JASPER & HART CREOSOTE SUPERFUND SITES SOURCE and GROUNDWATER PLUMES

Value Engineering Study For U.S. Environmental Protection Agency Region 6

Study Date: July 10-12, 2007
Report
August 30, 2007

Illustration:

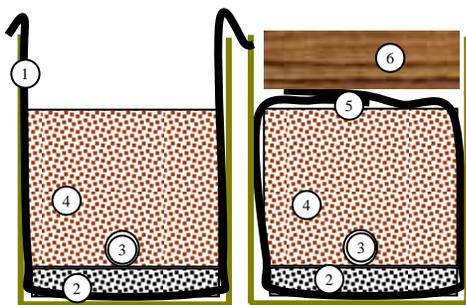
Eliminate geotextile in infiltration trench.

Original Design calls for excavation of infiltration trenches at each site and placement of a geotextile fabric at the base of each trench followed by coarse grained material (crushed limestone ¾ screen). CH2MHill estimates that Jasper will have a total trench length of 350 feet and Hart will have a total length of 750 feet. At 1.5 feet wide, using a complete-wrap design the textile will surround the gravel and have a perimeter of $1.5+2.5+1.5+2.5 = 8$ (feet). Therefore approximately 8800 square feet of geotextile will be required to line the trenches with a width of about 8 feet.

Fabric / 0.5 ft / pipe / 2ft / fabric (fabric on the sides as well – see illustration below)

Install crushed limestone at the base of each trench with delivery piping on top of the material and covered by the crushed limestone. Therefore approximately 2200 square feet of geotextile will be required to line the trenches with a width of about 2 feet.

Excavated base / 0.5 ft / pipe / 2 ft / fabric.

Fabric installed initially (1) followed by fill gravel (2) then pipe placement (3) and cover fill gravel (4). Finish by folding over fabric (5) and placing general fill (6).

Fill gravel (1) pipe placement (2) and cover fill gravel (3). Finish by placing fabric over gravel (4) and placing general fill (5).
